PROJECT: Hualapai ? Isaac Newton Single Family Residential

SUBMITAL: 1st

CITY OF LAS VEGAS		DATE:
INTER-OFFICE MEMORANDUM		August 10, 2020
TO: Land Development Services Department of Building & Safety		FROM: Albert Sung, P.E. Flood Control Project Engineer Department of Public Works
SUBJECT:	Drainage Study for:	COPIES TO:
	Hualapai & Isaac Newton Single Family Residential	VTN Nevada
Cross Streets:	NEQ of Hualapai Way & Isaac Newton Way	AMH Development West GC, LLC
File Number:	F:\Depot\DSMemos\DS5297A.doc	Bart Anderson, P.E., DevCo
Parcel Number:	138-07-401-001	
Zoning Action:	GPA-77926; MOD-77927; SDR-77928; TMP-77930 & VAR-77931	
FEMA Flood Zone	YES NO X	
Proposed Storm Drain	YES NO X

TYPICAL SECTION Q
NTS

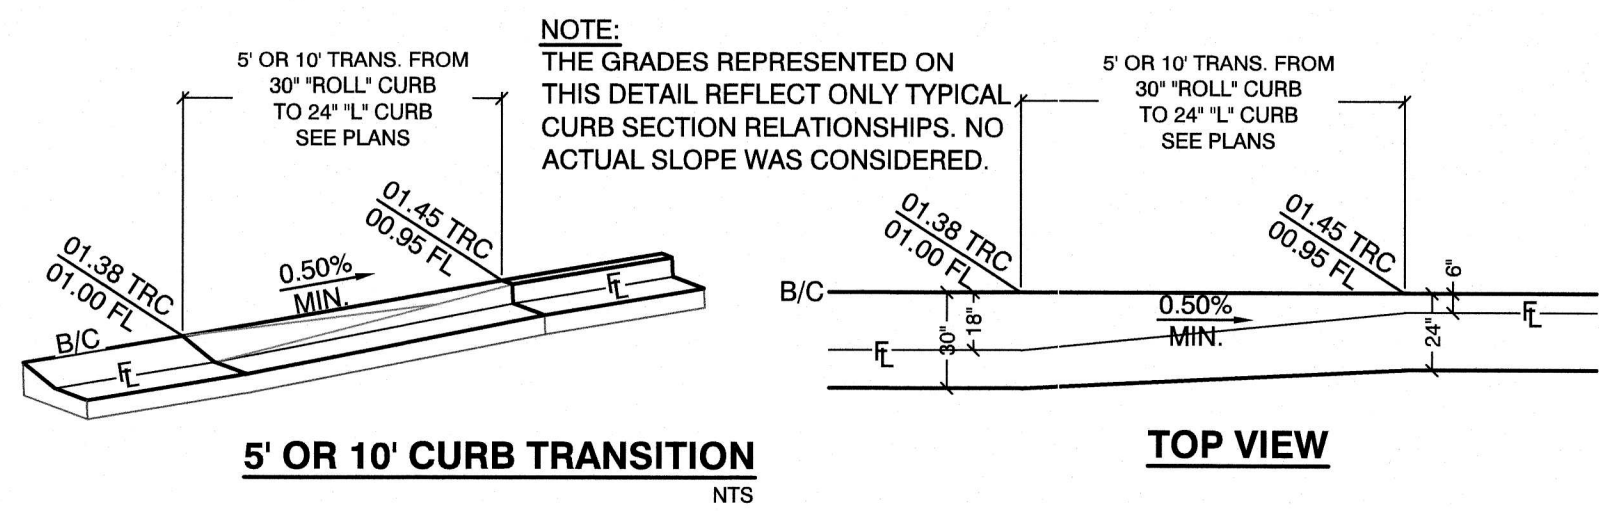
15. **Sheet DT1:** Typical Sections I, L and Q: Clearly specify the bottom 3 courses of the floodwall to be solid grouted 8”-CMU or equivalent thickness block.
